JENSEN-HEALEY SERVICE BULLETIN

No. JH 205

MARCH, 1974

FIG. 1. FACIA MODIFICATION.

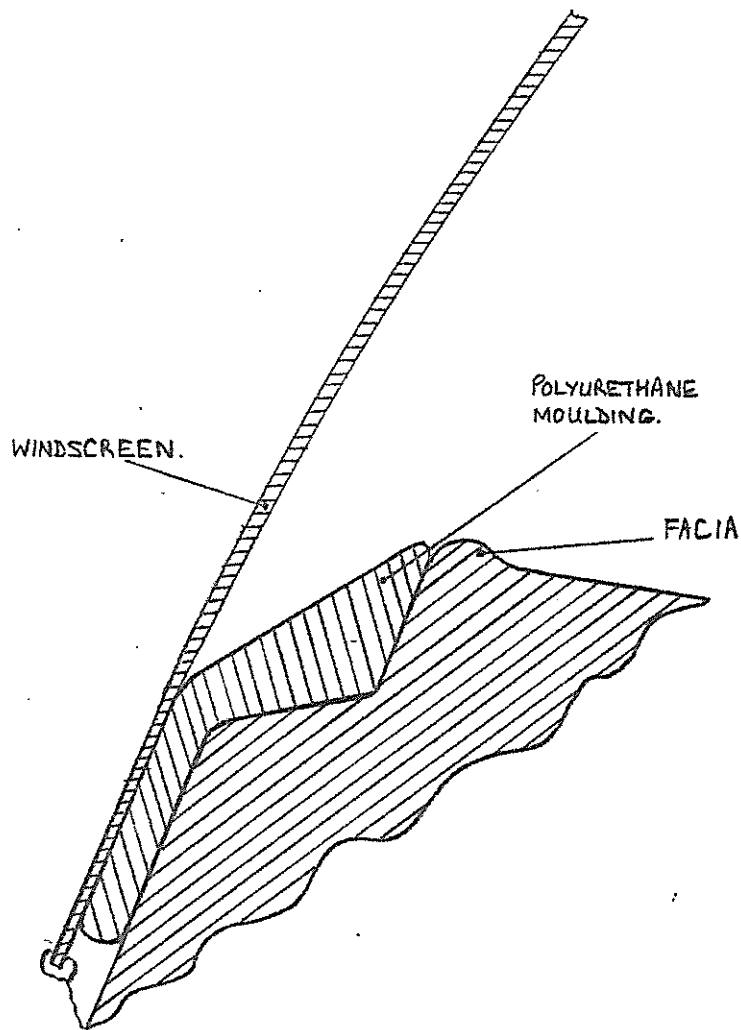
Because of isolated reports of the facia material lifting at the front edge, a service fix has been introduced. If this fault occurs, a polyurethane moulding is available and should be inserted between the facia and windscreen as shown on figure 1 attached using Evostik or Dunlop 1358 adhesive to keep in place. The adhesive should be applied to the moulding and allowed to dry completely, and then applied to the top of the facia and left for between two and three minutes, after which time the moulding should be pushed into position.

The moulding may be ordered direct from Jensen Motors Ltd., quoting Pt. No. 97492 (coarse grain) or Pt. No. 97491 (fine grain).

FIG. 2. LOCATION OF AUXILIARY HOUSING AIR BLEED HOLE.

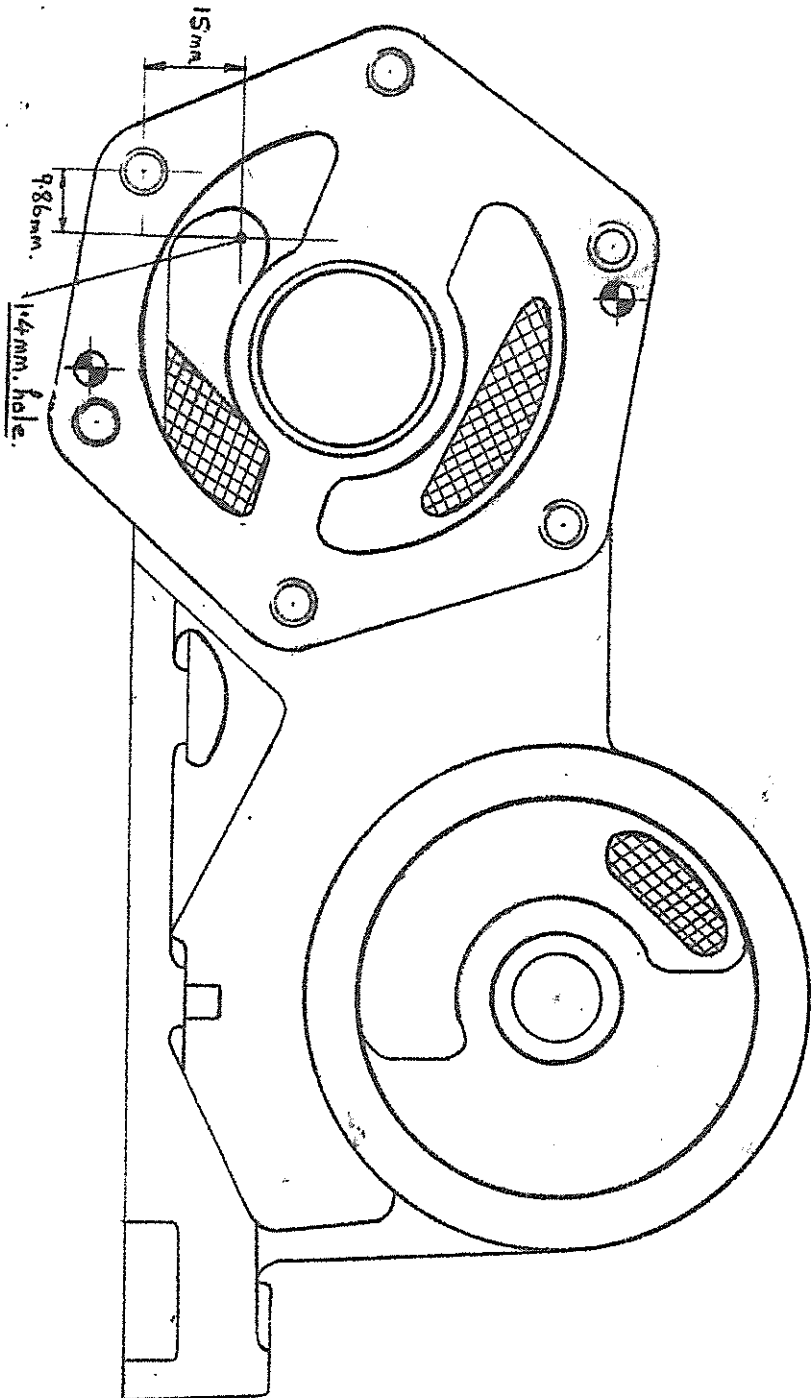
To decrease the oil pressure build up time, an air bleed hole has been incorporated in production (at Chassis No. 14875) on the pressure side of the oil pump housing within the auxiliary housing. This hole will allow air trapped in the oil galleries to be pumped out and therefore assist pump priming.

Should a problem of delay in oil pressure build up be experienced, the auxiliary housing may be modified as follows:-

- (i) Remove camshaft belt.
- (ii) Remove the auxiliary housing from the engine.
- (iii) Remove the pump from the auxiliary housing
- (iv) Remove the circlip retaining the oil pump gear to the drive shaft and withdraw the gear.
- (v) Drill a 1.4 mm. (No. 54 drill) hole in the auxiliary housing as shown in figure 2 attached.

FIG 3 TWIN DELCO-ROMERO PHLA 40E
CARBURETTORS

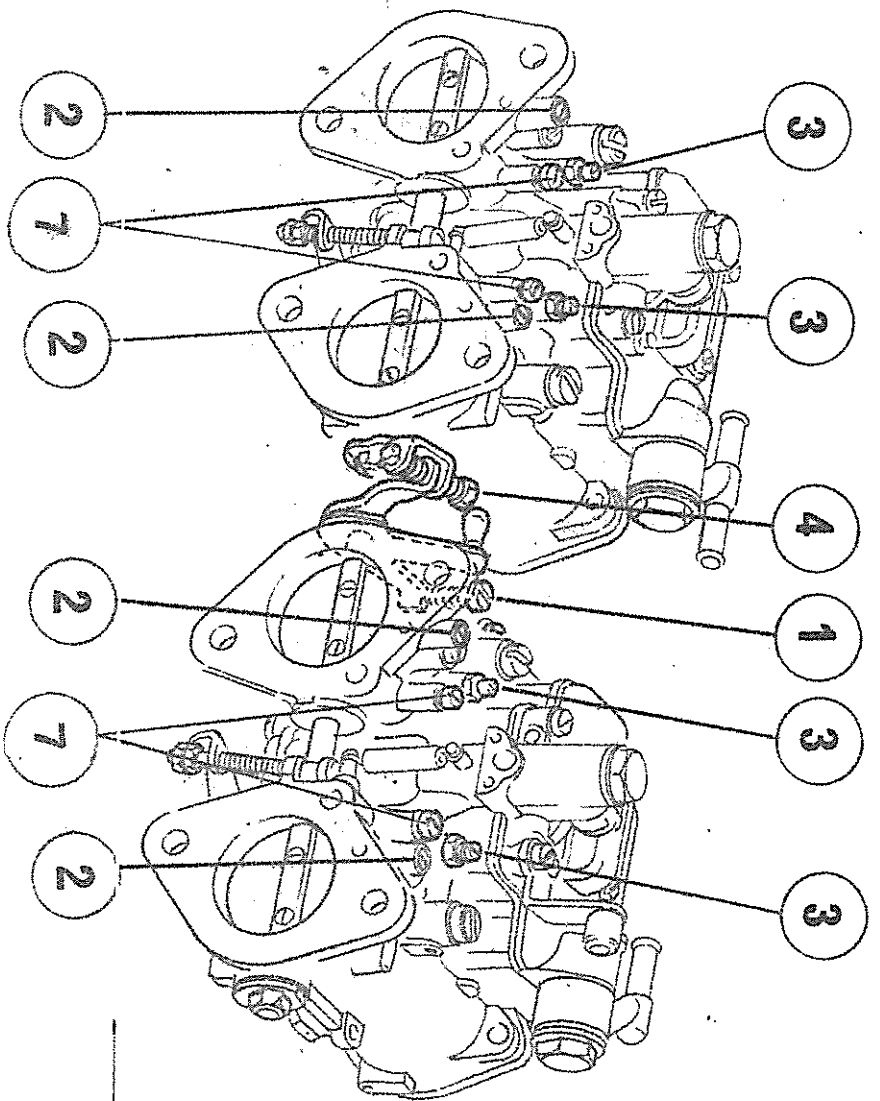
For information purposes, this bulletin outlines the correct procedure for synchronising and tuning twin Dellorto DHLA 40E carburettors:

- (a) Warm up engine to the normal operating temperature
- (b) Switch off engine and unscrew the central throttle stop screw (1) until it is visibly well out of contact with the lever extension. This allows the forward throttle butterflies to close completely.
- (c) Slowly screw in the central balance connecting lever screw (4); this forces the rear throttle butterflies to close and it will be seen that the rear carburettor throttle spindle is gradually closing while the forward spindle stays closed. Continue screwing in until the rear throttles are fully closed.

- (d) Screw the throttle stop screw (1) back into contact with the lever, and then in about three more turns.
- (e) Disconnect the front two spark plug leads and start the engine to run on the rear two cylinders only, with the idle speed steady at about 1,000 r.p.m. if possible.

(f) Adjust the two idle mixture screws (2) on the rear carburettor to obtain the fastest even running (screw adjustment is very sensitive). If the idle mixture of one of these two operating cylinders is adjusted away from its optimum setting, the engine will respond by noticeably slowing down, shaking or stalling. When this operation has been accomplished satisfactorily, stop the engine and repeat with only the two front plug leads connected.

(g) Connect all four plug leads, slow the idle speed down to 800 r.p.m. using the throttle stop screw (1) and blip the throttle quickly once or twice. If the engine does not "pick up" cleanly, but instead vibrates, hesitates or shakes, adjust the balance screw (4) setting very slightly until the best position is found i.e. where the engine picks up without hesitating or shaking. In this position, both pairs of carburettor throttle butterflies should be opening together from the same slightly-open setting.

(h) Fit a CO meter and note the reading obtained; this should be 1 - 2%. If the CO level is outside these limits, the procedure shown below should be followed:-

- (i) Screw all four mixture screws (2) fully in and then out six full turns.
- (ii) Back off completely the throttle stop screw (1) and then in about three full turns.

- (iii) Loosen the locknuts on the four bypass screws (3) and screw down into light contact with their seats.
- (iv) Connect a tachometer and start the engine.

- (v) Obtain the correct idle speed (900 - 1,000 r.p.m.) by adjusting the throttle stop screw (1).
- (vi) Remove the four manifold depression blanking screws (7) and connect to their orifices the rubber tubes of a four-column mercury vacuumeter. Adjust the central balance connecting lever screw (4) so that the mercury levels in the two central columns of the vacuumeter are equal; then adjust the bypass screws (3) on the outer barrels so that all the mercury column levels are equal. (Note: If a vacuumeter is not available, then this operation may be carried out using proprietary balancing equipment).

- (vii) Obtain the best even running by adjusting the four mixture control screws (2). Recheck that the mercury levels are still equal (or recheck for equal breathing) and correct if necessary by adjustment of the bypass screws (3). Tighten the four bypass screw locknuts.
- (viii) Reconnect up the CO meter and recheck the reading obtained. If higher than 2%, screw in each mixture screw by 1/16th. of a turn and recheck. Repeat this operation until the correct CO level is attained. If the reading is below 1%, then the same operation must be carried out but by unscrewing each mixture screw (2) in increments of 1/16th. of a turn.

FIG 4. LOCATION OF ATTACHMENT BRACKETS.

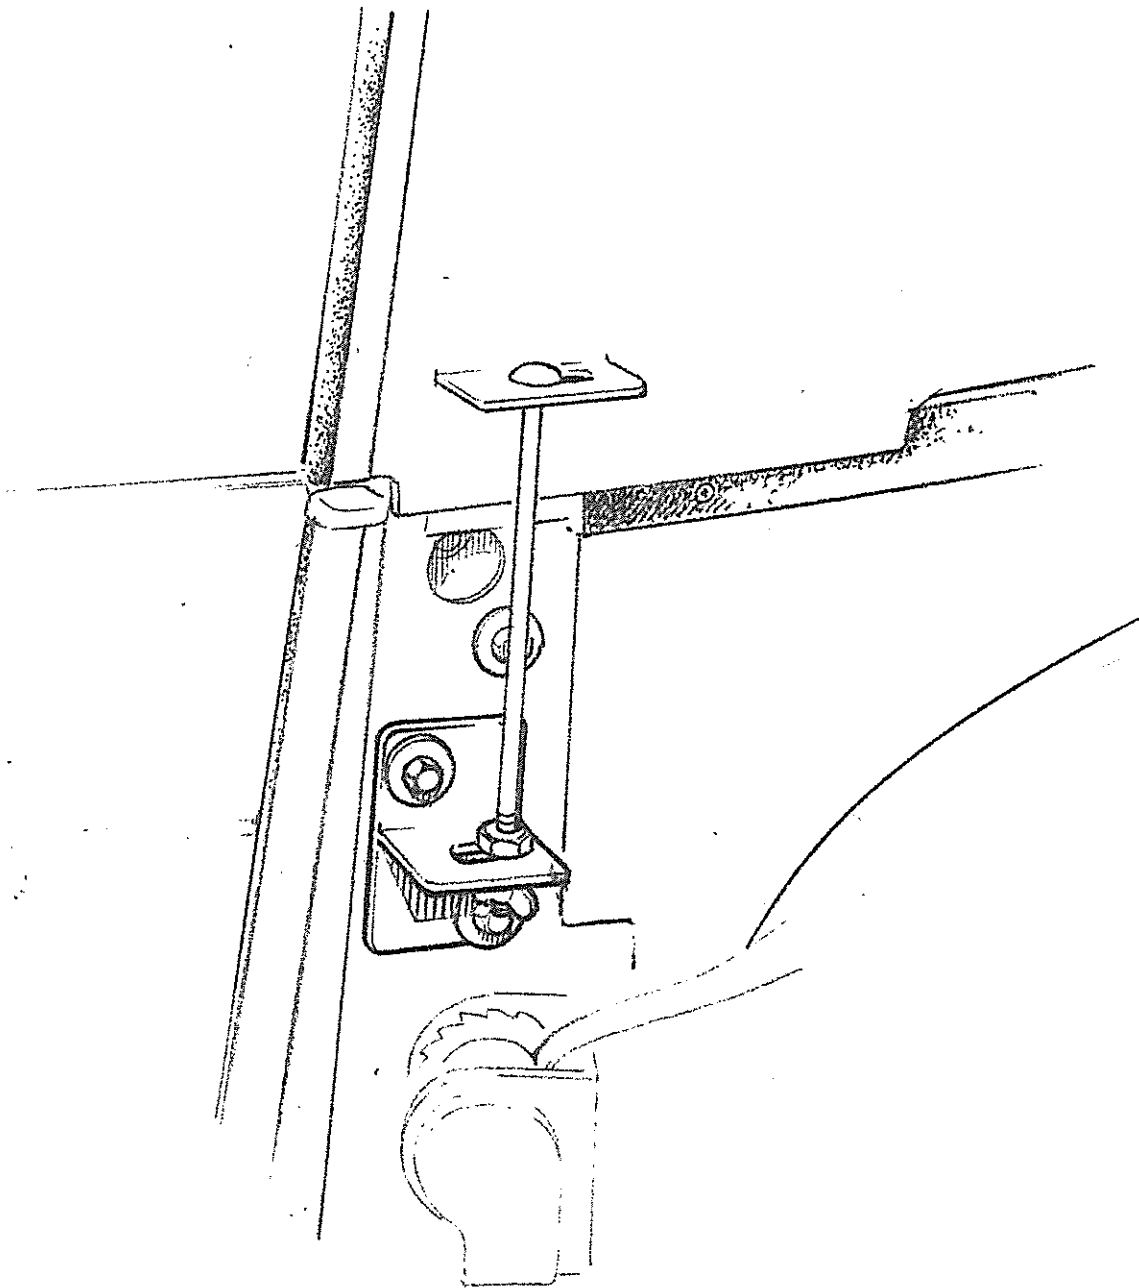
It is advisable to completely remove the soft top and frame assembly. Release the header rail locking levers, detach the rear of the soft top from the retainers on the deck panel and remove three set screws from each frame mounting plate. The nut plates to which these set screws attach will drop down inside the wing if not held. They can easily be retrieved after removal of quarter trim panels. Fit the left hand and right hand attachment brackets using two of the original three set screws. Mount in the two lower frame attachment holes. See fig.4.

FIG. 7. BACKLIGHT HARNESS WIRING DIAGRAM.

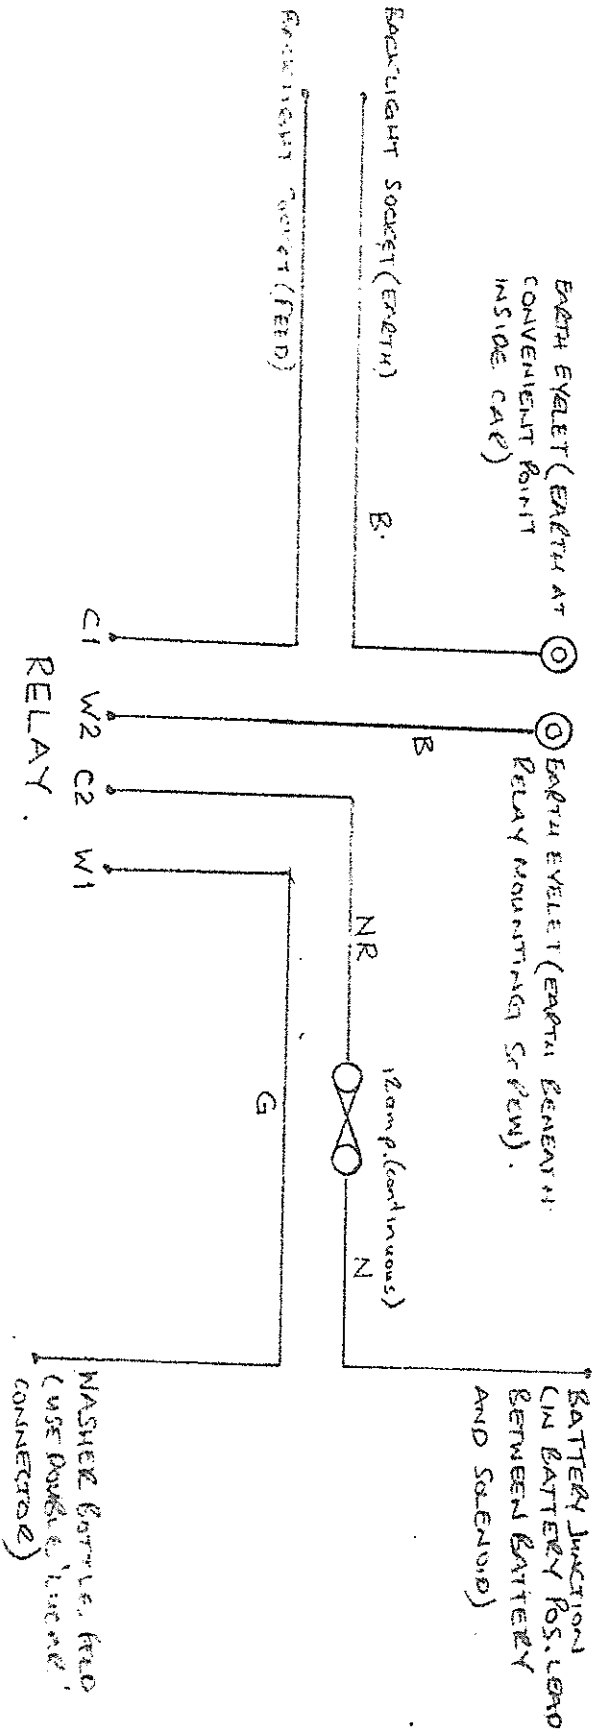
Mount the Lucas 6RA relay alongside the fuse holder on the bulkhead with two screws provided. Connect in the backlight feed harness as shown in the attached wiring diagram, see fig.7., passing it through a bulkhead grommet. Detach one side of the rear bulkhead trim panel and run the harness along one edge of the floor carpets. Pass the harness behind the trim panel.

The backlight harness Part No. 97177 will shortly be available from Parts Department, and until it is, dealers may make up a harness as shown in fig.7.
